Access Compliance Report Public Rights-of-Way (Curb Ramps)

Main Street: WILLO_LN Cross Street: UNIVERSITY_DR Location: W

ADA ID: RPRK211018112052 Ramp Type: Type 6 - Directional 1 Initial Pass/Fail: Fail Overall Compliance: No Severity Score: 2

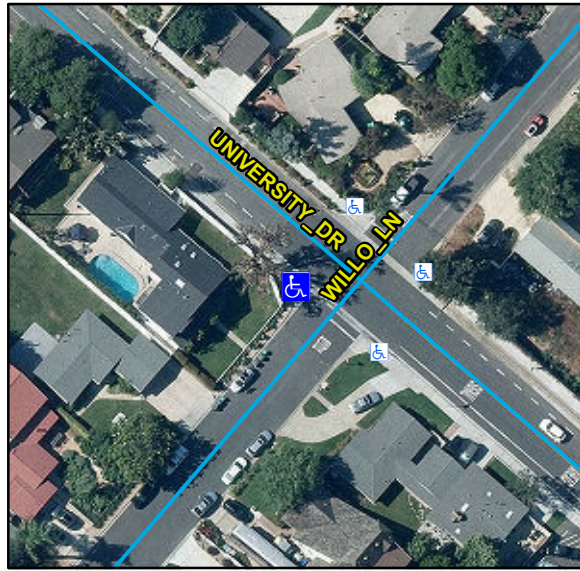
Compliance	Description	Data	Compliance	Description	Data
N/A	Ramp Length (in)	182	N/A	Flare Type LT	
Yes	Ramp Width (in)	59			N/A
Yes	Ramp Run Slope (%)	5	N/A	Flare Slope LT (%)	N/A
No	Ramp Cross Slope (%)	2.1	N/A	Flare Traversable LT	N/A
N/A	Grade Break	N/A	N/A	Flare Type RT	
N/A	Grade Break Slope (%)	N/A			N/A
N/A	Grade Break Cross Slope (%)	N/A	N/A	Flare Slope RT (%)	N/A
	Addl Para Ramp Left?	No	N/A	Flare Traversable RT	N/A
	Addl Para Ramp Right?	No	N/A	DWS Provided	N/A
N/A	Landing Present	N/A	N/A	DWS Contrast	N/A
N/A	Landing Length (in)	N/A	N/A	DWS Length (in)	N/A
N/A	Landing Width (in)	N/A	N/A	DWS Full Width	N/A
N/A	Landing Run Slope (%)	N/A		DWS Offset Type	N/A
N/A	Landing Cross Slope (%)	N/A	N/A	DWS Left Offset (in)	N/A
N/A	Landing Movement Obstructed?	Yes	N/A	DWS Right Offset (in)	N/A
	Landing Movement Type	SS			
N/A	Landing Shared	N/A			
N/A	Marked Crosswalk 1	No	N/A	Clear Space	N/A
	Crossing 1 Direction	SE	N/A	Clear Space To Crosswalk (in)	N/A

Remove & Replace Entire Ramp.

R304.5.3, STD 1115
